PREVOST

WARRANTY BULLETIN

WB24-02

DATE :	April 2024	SECTION :	18 BODY
EXPIRATION:	April 2026		
SUBJECT :	PARCEL RACK DOORS RUBBER BUMPER STRIP REPLACEMENT

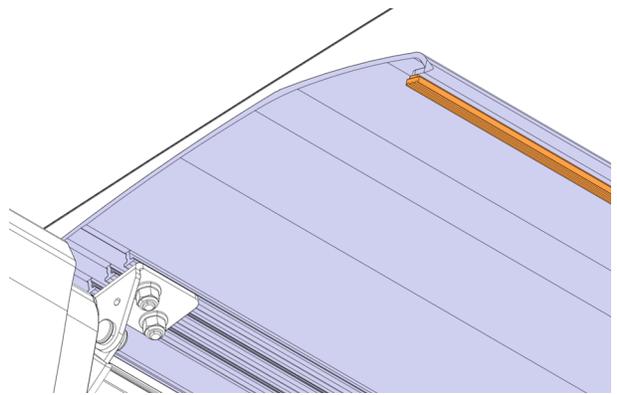
1. Open the parcel rack door.

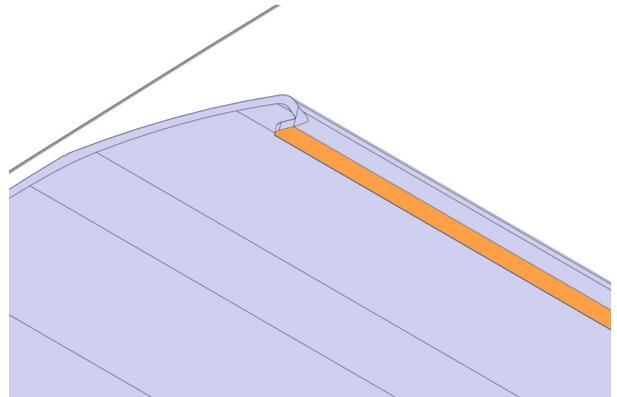
2. Remove the old rubber bumper strip.

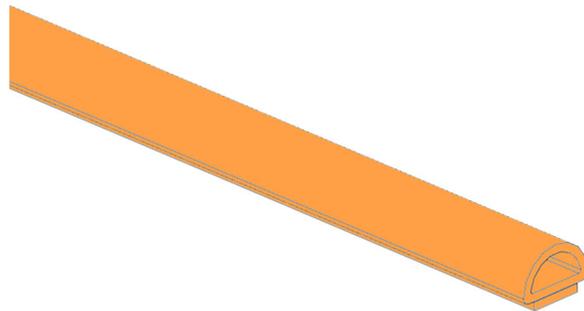
4. Cut a length of a new strip of rubber 506217.

Length:

- 1654 mm (65.1 in)
- 1269 mm (49.9 in)

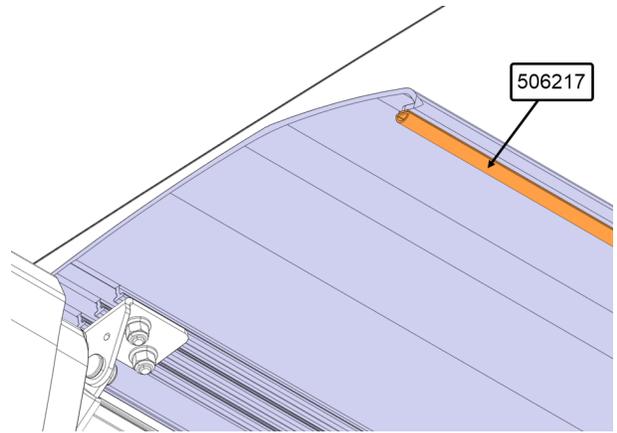
5. Install the new rubber 506217.

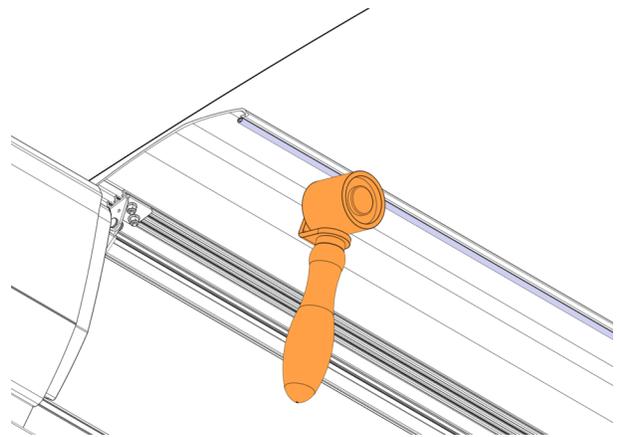
6. Roll to exert pressure on the new rubber strip.
